Subject: Corrections / Clarifications to the Exelon Early Site Permit (ESP)
Application Environmental Report for the Clinton ESP Site (TAC No.
MC1122)

Enclosure 1: Corrections / Clarifications to the Environmental Report of the Exelon
ESP

Figure 2.3-3 Postdam Peak Flood Magnitudes and Frequencies for Salt Creek at Rowell Gauge Station

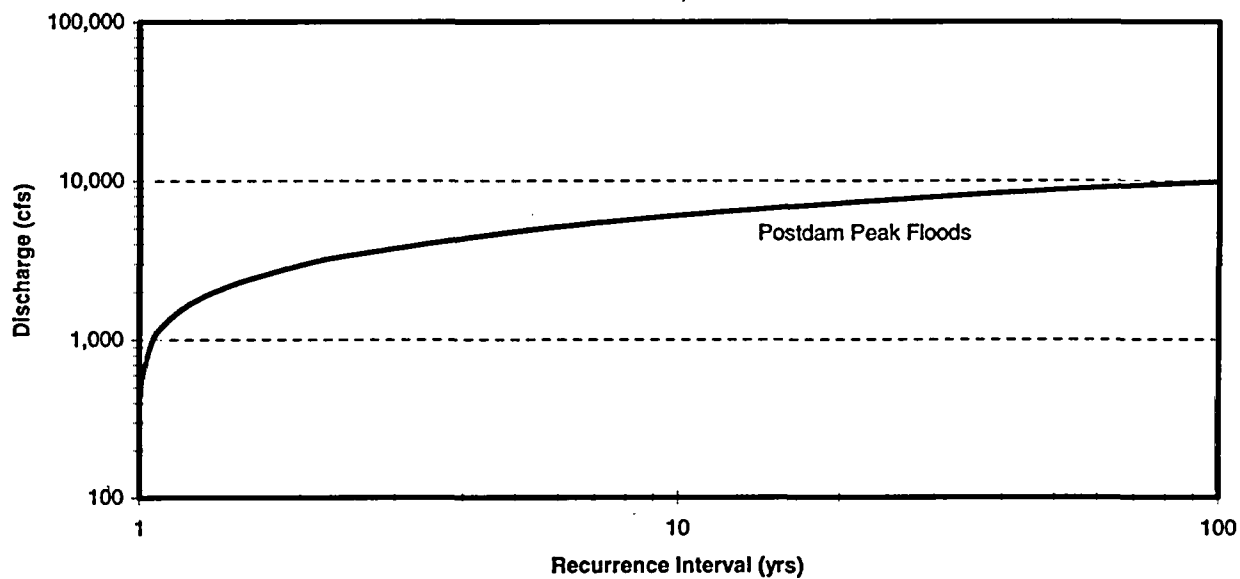
The flood frequency estimations for the Rowell gauge were re-examined based on discussions with the NRC during their site audit and the SSAR RAIs where NRC noted minor discrepancies with the discharge data. EGC has reviewed the statistical analysis of the historical discharge data at the Rowell gauge and identified areas to be revised. In summary, the period of record for the historical data was updated as more data are now available than at the time of the original analysis (analysis now includes Water Years 1979 through 2003); and EGC has revised the latitude and longitude of the input to the USGS DOS-based program (Peak FQ) which is the Log Pearson Type III analysis as described in WRC Bulletin 17B to more closely reflect the location of the gauge.

4. Replace Figure 2.3-3 with:

Flood frequency for the Rowell gauging station were calculated using a Log-Pearson Type III distribution based on the 25 years of records from Water Year 1979 through 2003. Figure 2.3-3 shows the peak flood frequency curve for Salt Creek at the gauging station under post-dam conditions. The peak flow for various recurrence intervals at the gauging station and at the dam are also shown in Table 2.3-4. The discharges at the dam site were derived using the drainage area ratio.

Figure 2.3-16

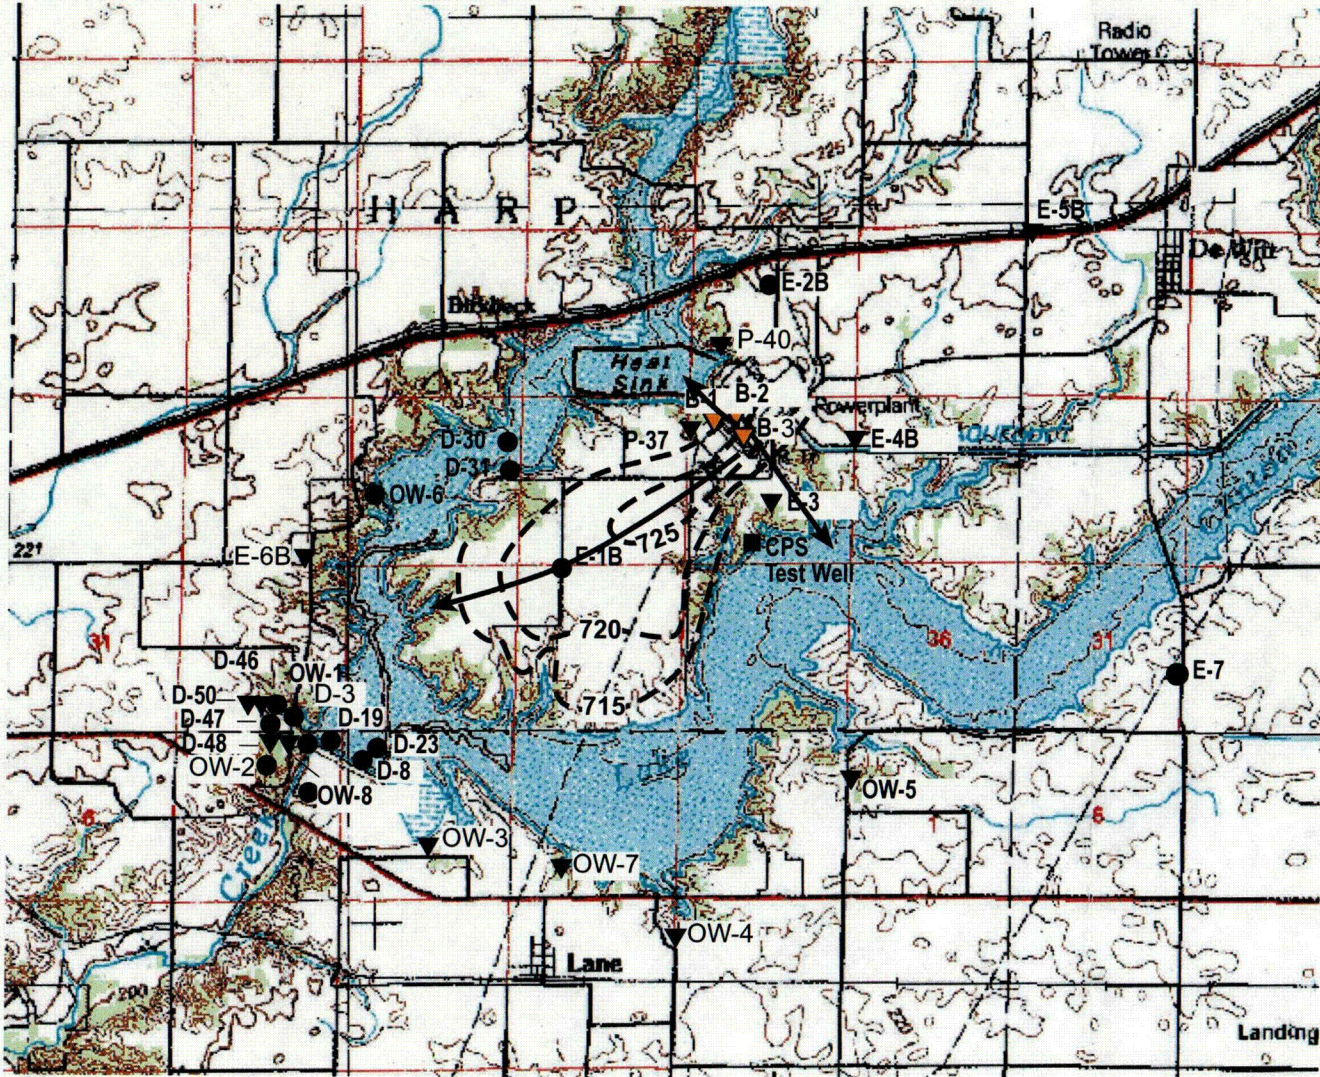
Water table elevations shown on the figure were incorrect (not consistent with the flow arrow). Elevations on Figure 2.3-16 were modified by switching the "715" and "725" contour levels.

1. Replace ER, Chapter 2, Section 2.3, Figure 2.3-16 with Attachment 1
